Landscape Referral Response

Application Number:	Mod2025/0018
Date:	11/06/2025
Proposed Development:	Modification of Development Consent DA2023/1869 granted for Demolition works and construction of a Residential Flat Building including the consolidation of 3 lots into 1 lot
Responsible Officer:	Phil Lane
Land to be developed (Address):	Lot 5B DP 158658 , 58 Beaconsfield Street NEWPORT NSW 2106 Lot 6 DP 1096088 , 56 Beaconsfield Street NEWPORT NSW 2106 Lot 7B DP 162021 , 54 Beaconsfield Street NEWPORT NSW 2106

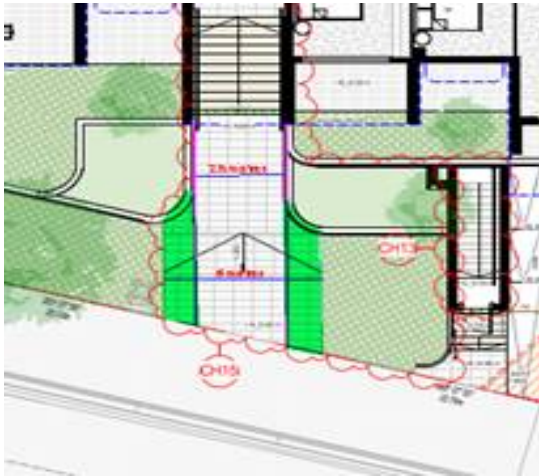
The location of the OSD under the western entrance footpath within the property raises no concerns. However, the width of the eastern entrance footpath at approximately 5 metres in width is not supported as this is not necessary to provide for access activities and the percentage of hardstand within the front setback diminishes the landscape area to an extent that impacts the presentation of the landscape setting as more prominent than the built form as required under Pittwater DCP.

It is suggested that the width of the eastern entrance footpath shall be aligned with the building entry

and external walling width as illustrated below. Amended Landscape Plans shall indicate mass planting to the landscape areas either side of the footpath to enhance the entry setting.

Architectural Plans are submitted that responds to the concerns previously raised with the width of the eastern entrance footpath reduced. No Landscape Plans were submitted as requested to co-ordinate all plans and thus a condition shall be imposed for co-ordinated Landscape Plans to ensure consistency with the front setback landscape setting outcomes.

DA2023/1869 Condition 10 Amended Landscape Plans shall be modified. Condition 61. Landscape Completion remains unaltered.
